No.	Date	Description
1	2025-09-19	Add No. 1
2	2025-09-30	Add No. 2

**WCFPD Station 3**  
**Wright City Fire Protection District**  
9 Highway WW  
Wright City, MO 63390

A322

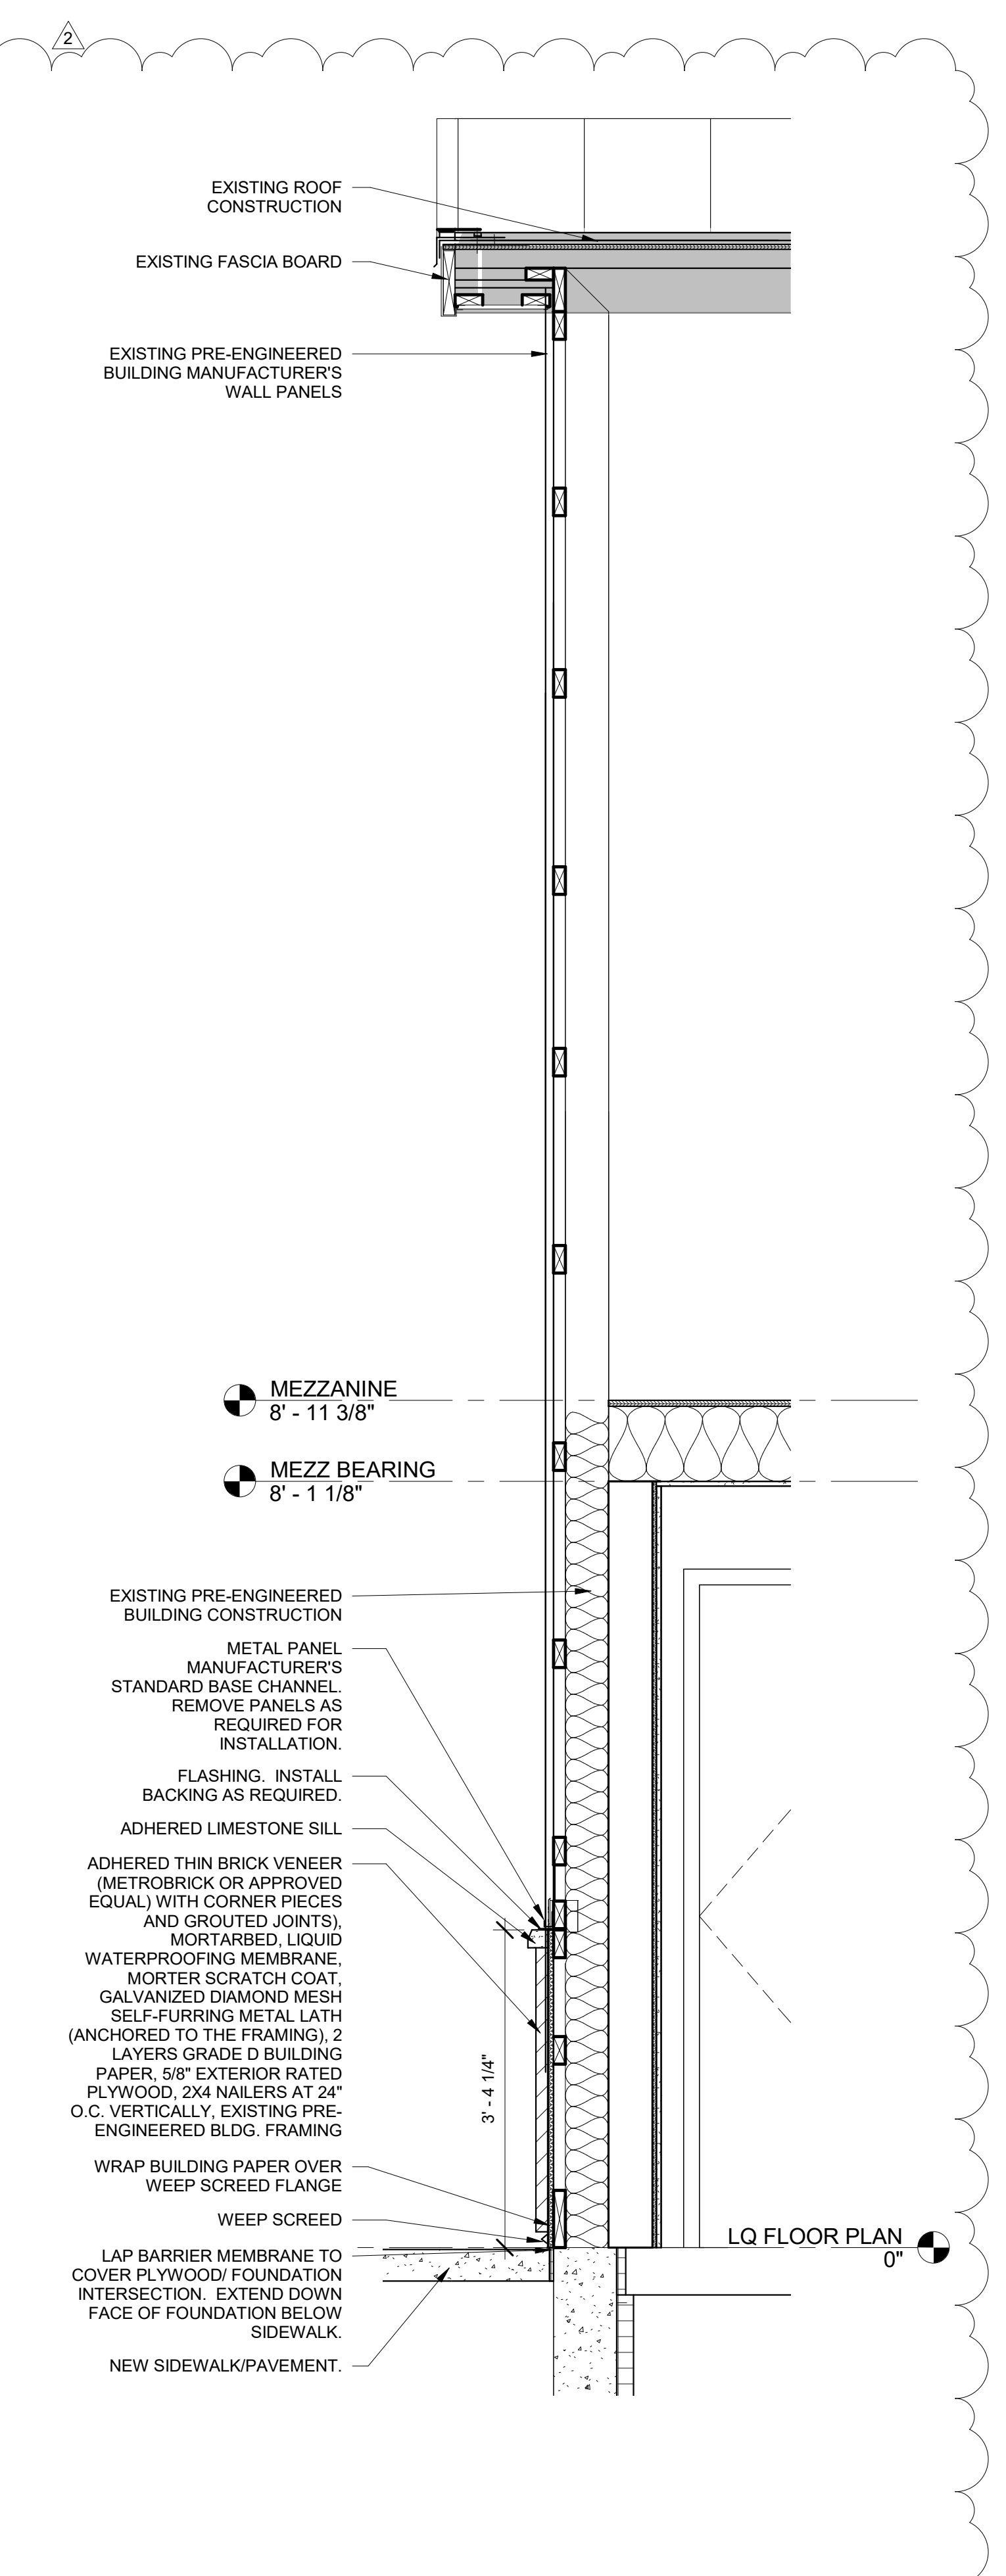
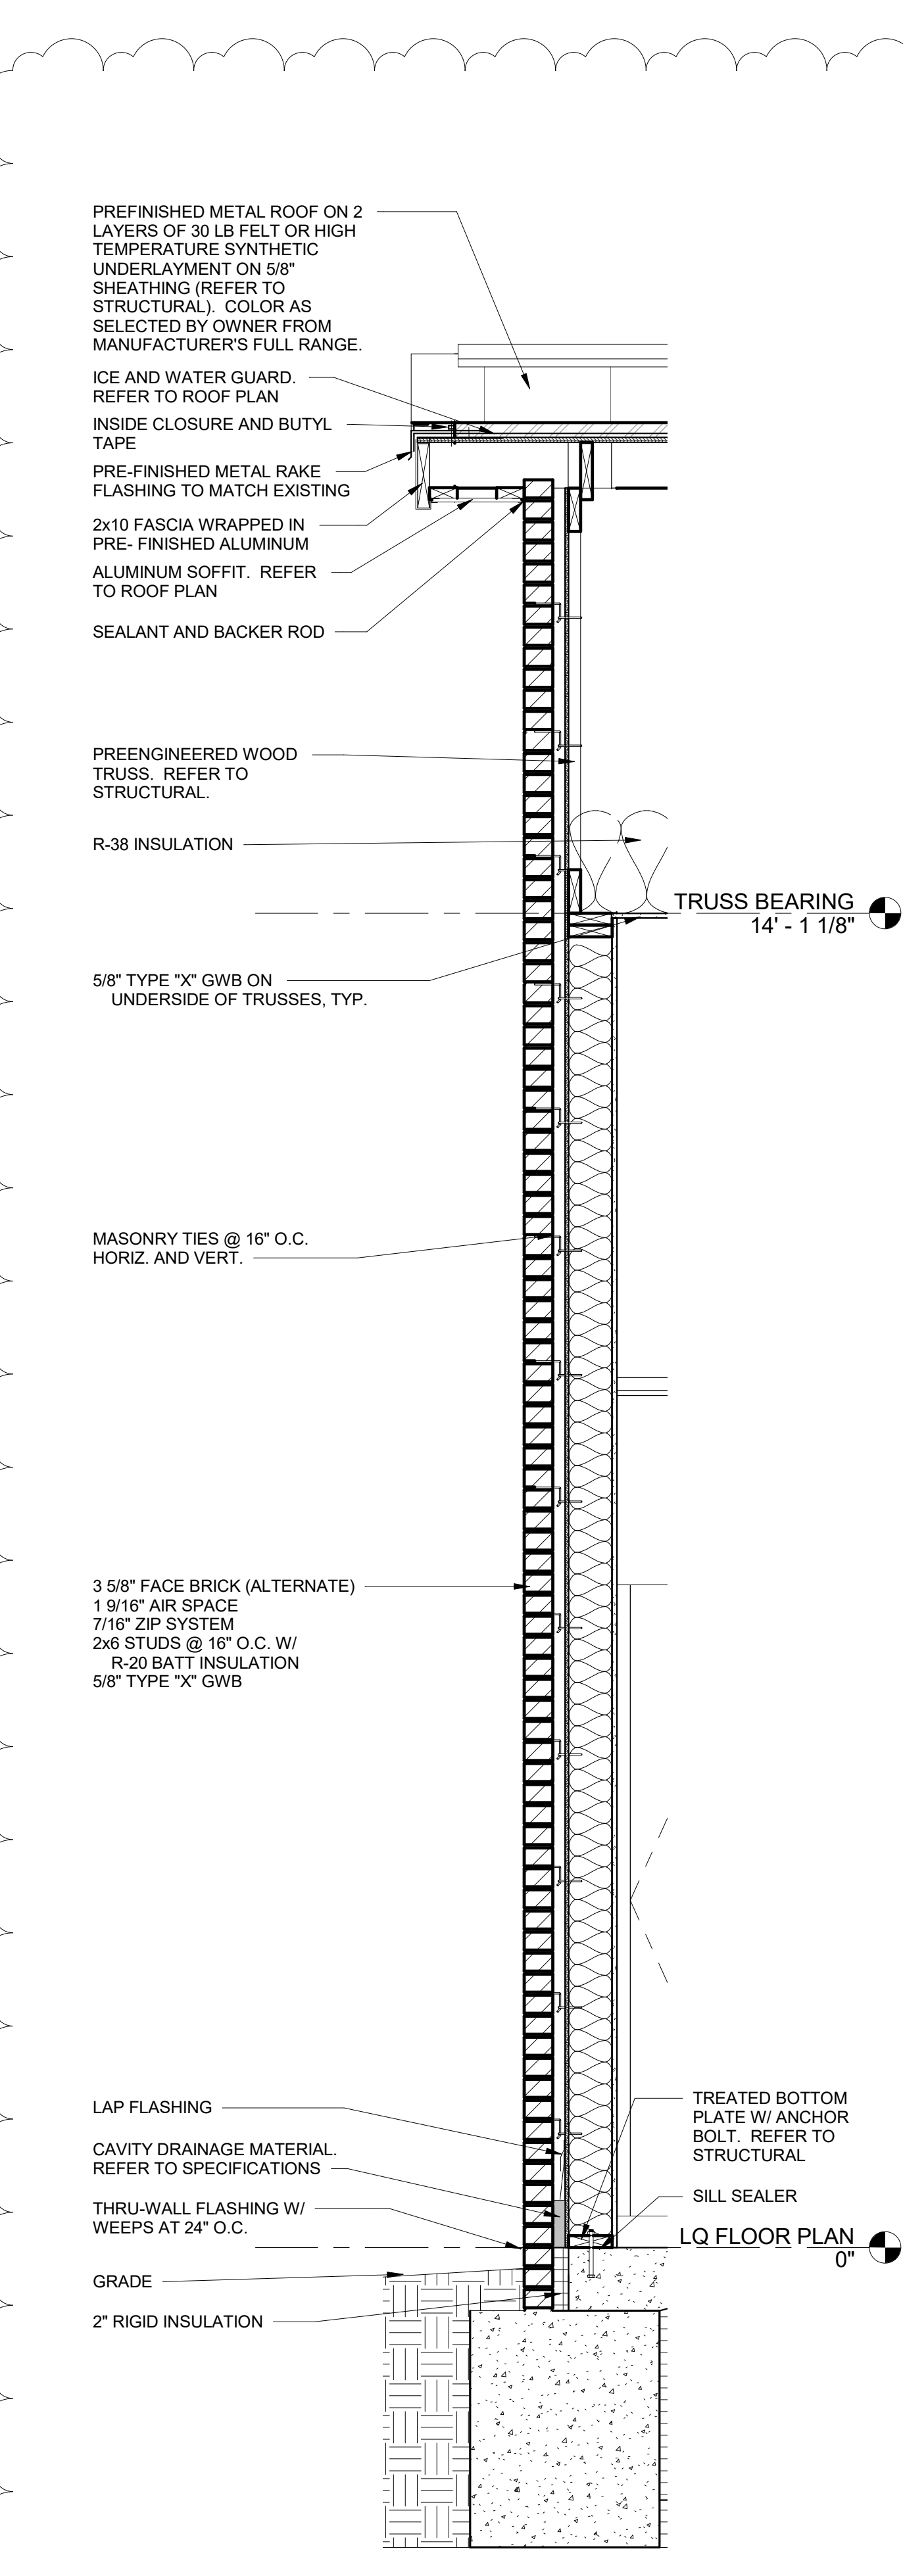
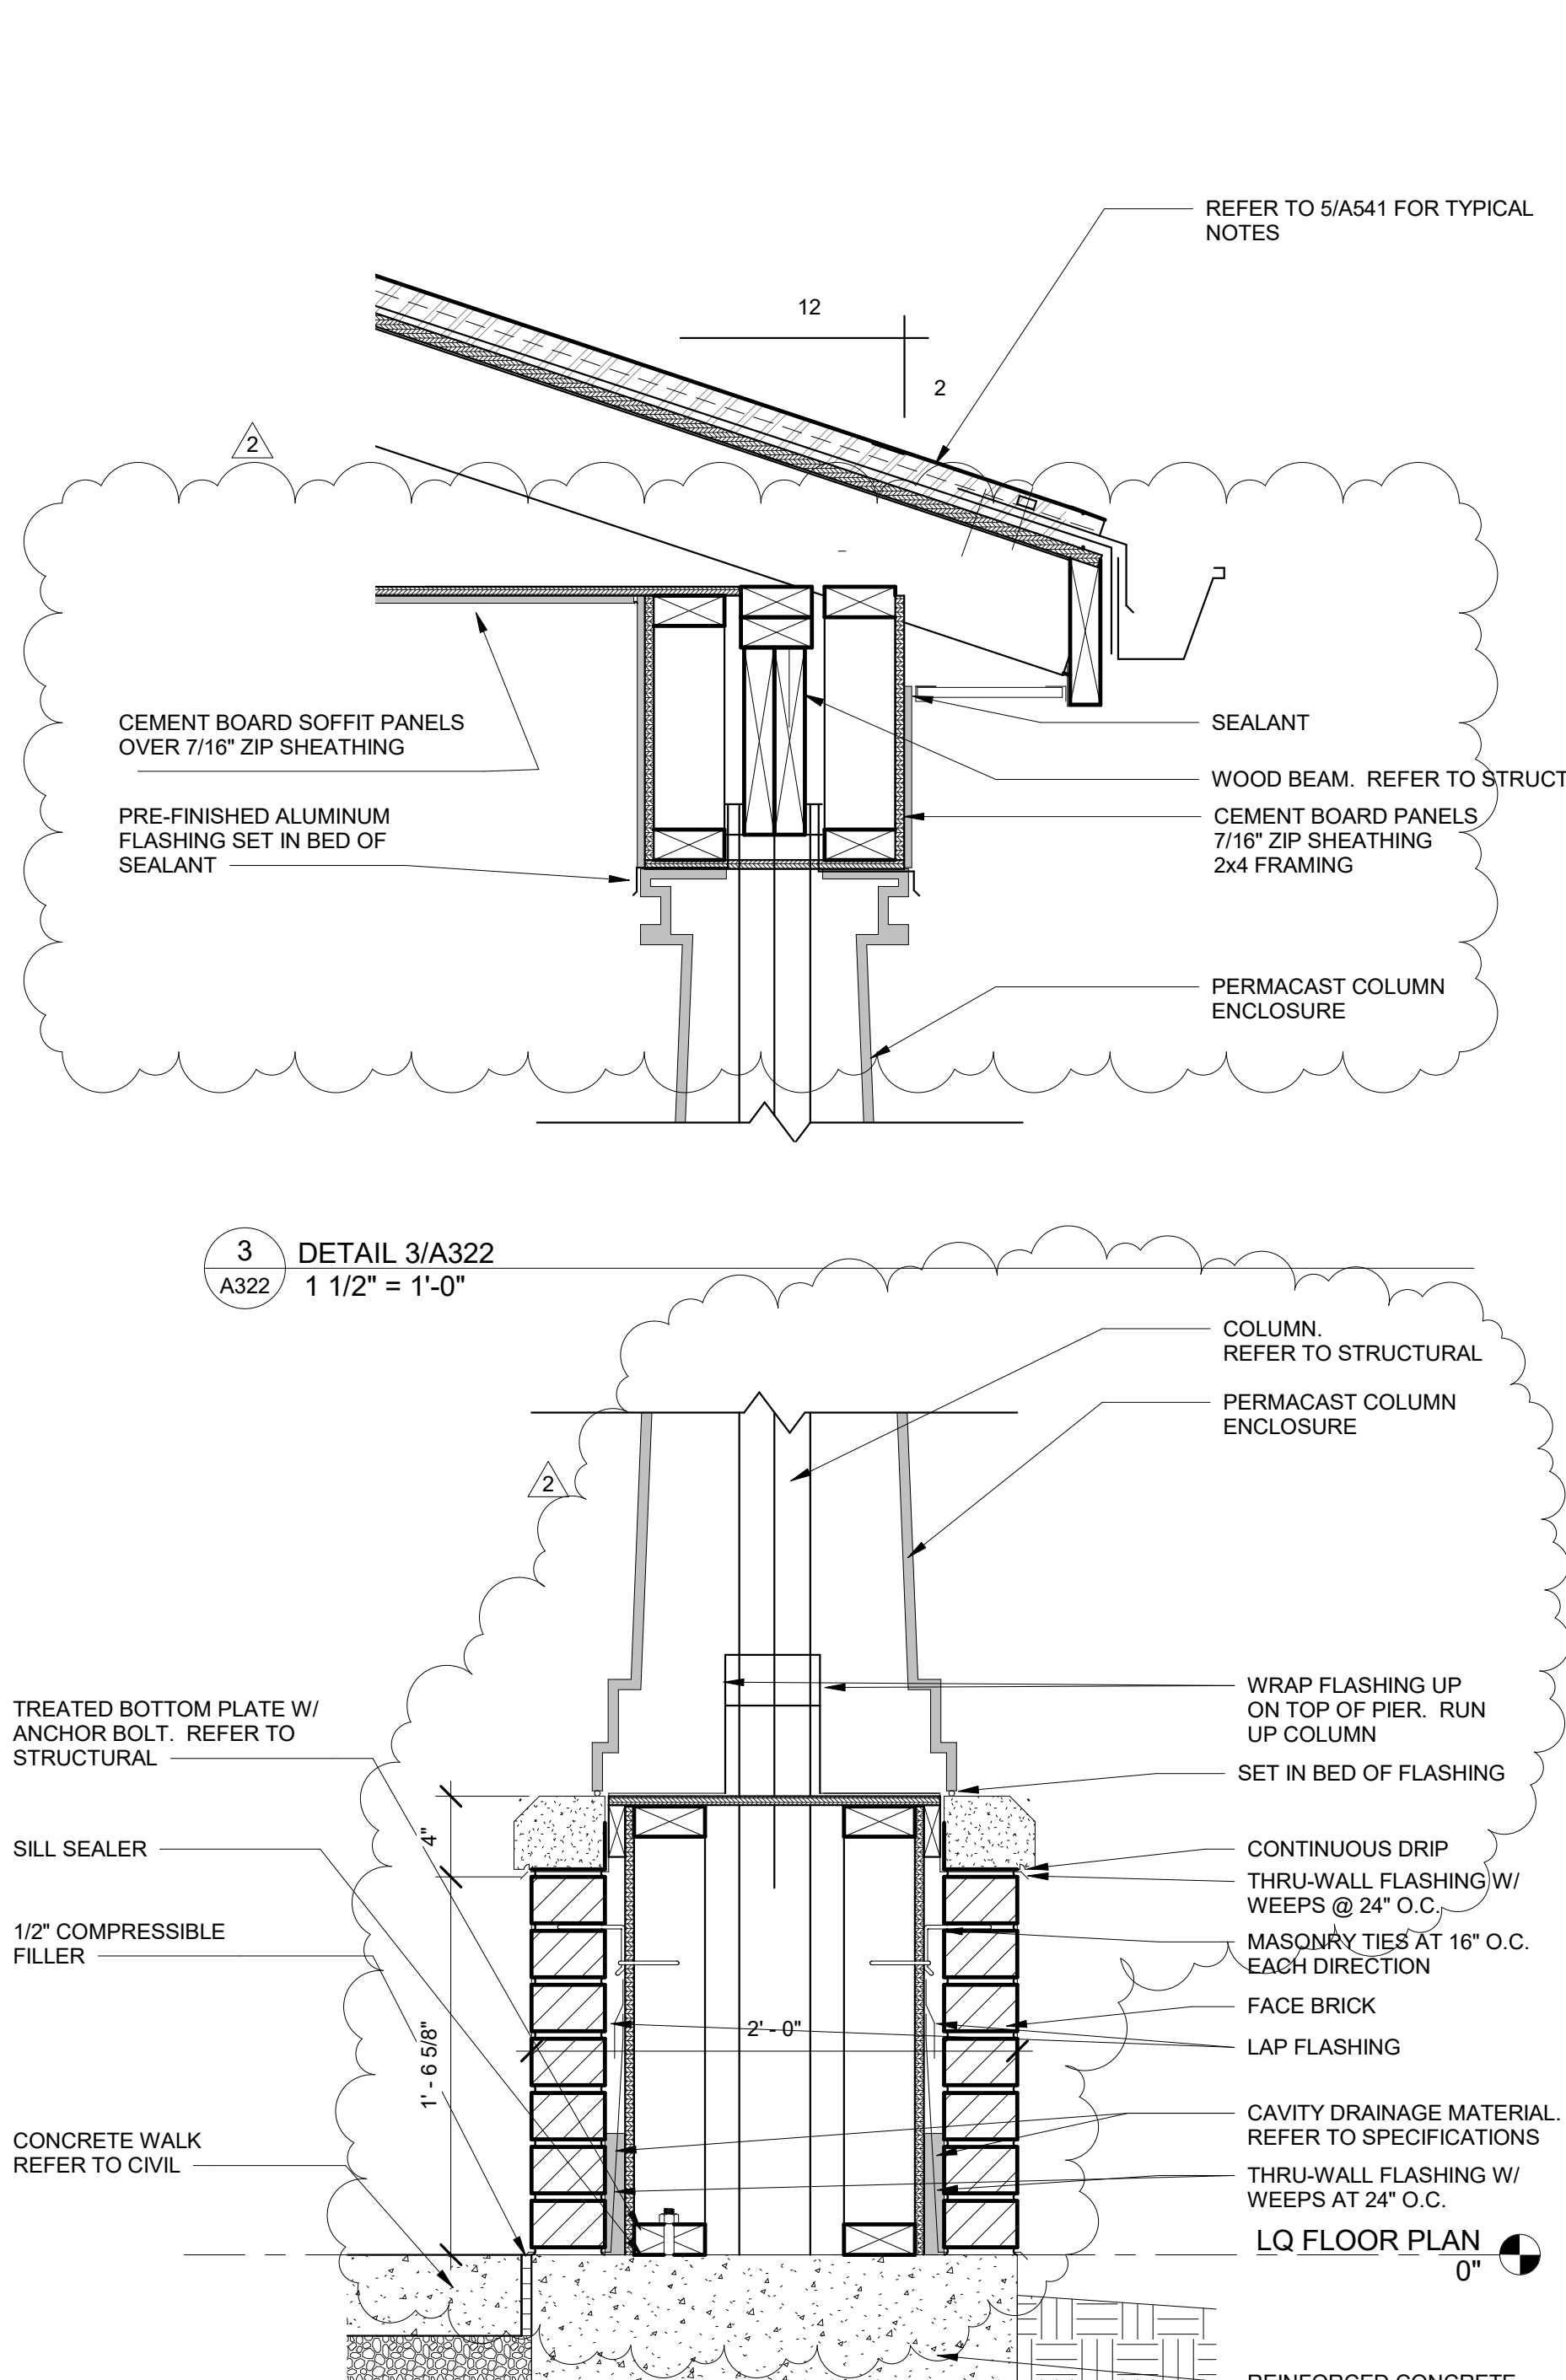
- 23) Sheet A321 – WALL SECTIONS
  - a. REVISE all wall sections.
  - b. ADD fireblocking note.
- 24) Sheet A322 – WALL SECTIONS
  - a. REVISE wall sections.

- b. ADD Wall Sections 5/A322 and 6/A322 for alternate brick veneer (at the North addition) and adhered thin brick (at the existing building and the South end of the new app bay).

- c. ADD fireblocking note.
- 25) Sheet A541 – SECTION DETAILS
  - a. REVISE details.
- 26) Sheet A601 – DOOR SCHEDULE AND PARTITION TYPES
  - a. REVISE Door 118A and add Door 201 in the Door Schedule.
